## **RE: Dalswinton Sand and Gravel Quarry (SSD-9094) - DPE Water Submissions**

This letter has been prepared to address comments and recommendations submitted by the Department of Planning and Environment (DPE) – Water (DPE Water) to DPE in a letter dated 3 March 2022 in relation to the surface water impact assessment (SWIA) prepared by Umwelt (Australia) Pty Ltd (Umwelt) the Rosebrook Sand and Gravel (RSG) Dalswinton Quarry Expansion project (the Project).

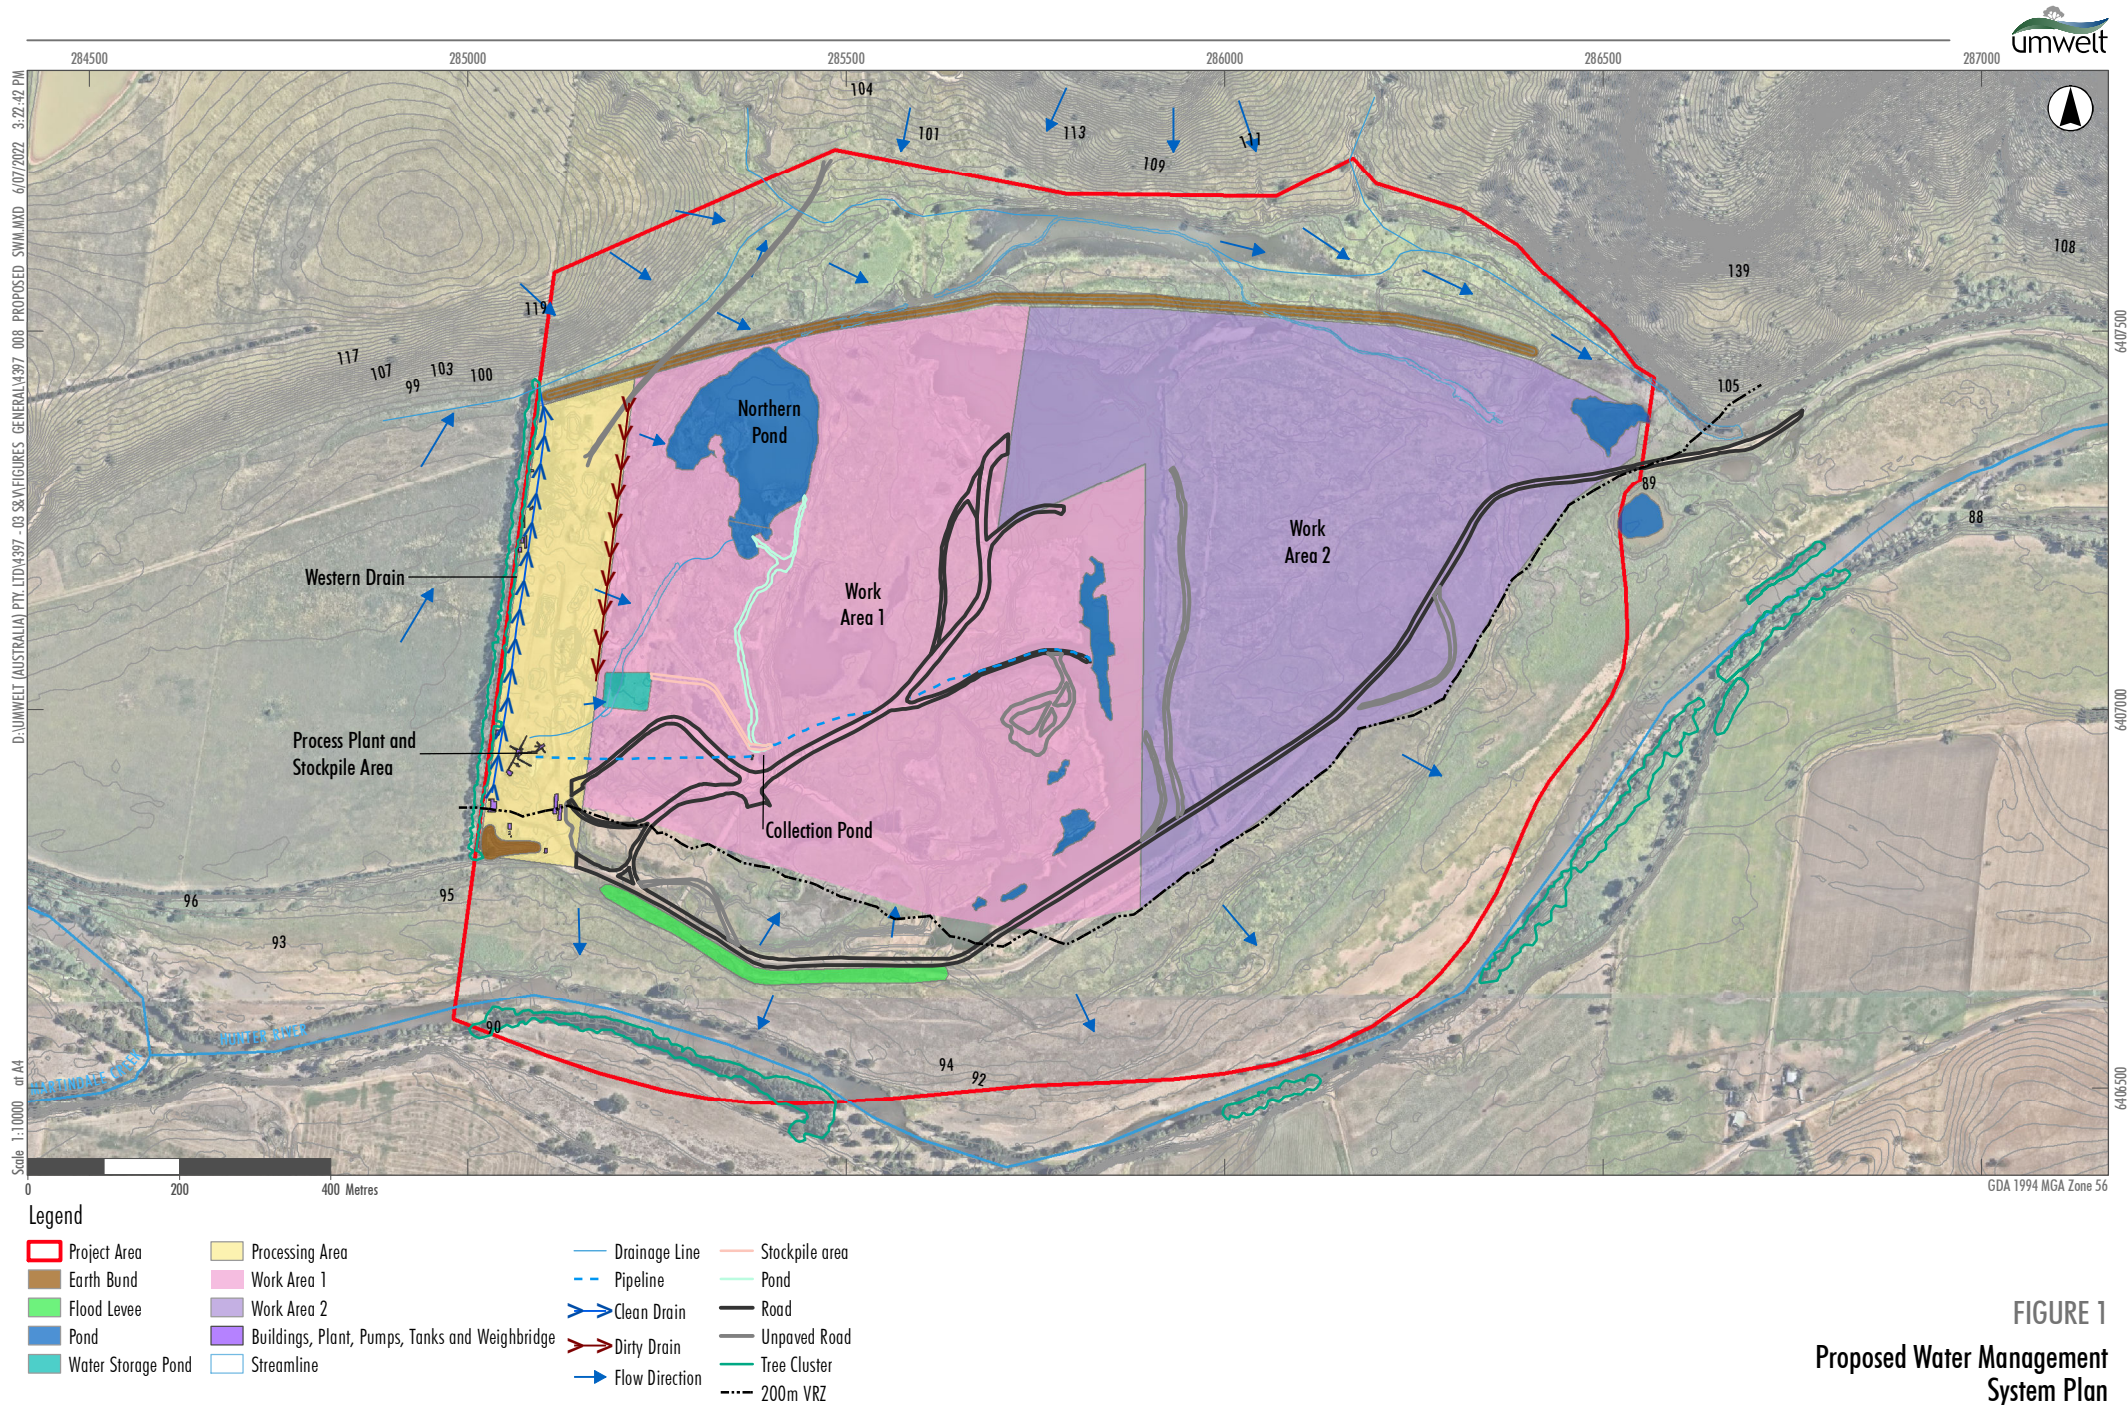
- 1.1 The proponent should provide clarification of the maximum groundwater and surface water take, site water demands and the ability to obtain additional water entitlement where required for the project.**

Following completion of the SWIA the water management system (WMS) proposed for the Project was revised to include a new Water Storage Dam (WSD). **Figures 1 and 2** (attached) present the current proposed WMS plan and schematic drawings respectively. The WSD was included to fulfill the functionality of the existing Northern Pond and has a lower storage volume and significantly lower surface area to volume ratio to limit evaporative losses. The WSD will be the primary water storage for supplying Quarry demands (i.e. sand and gravel processing, dust suppression), capturing runoff from the Process Plant and Stockpile area. The Northern Pond will remain as an environmental protection area but will not receive any inflows from operational areas of the Quarry or be used to supply Quarry water demands.
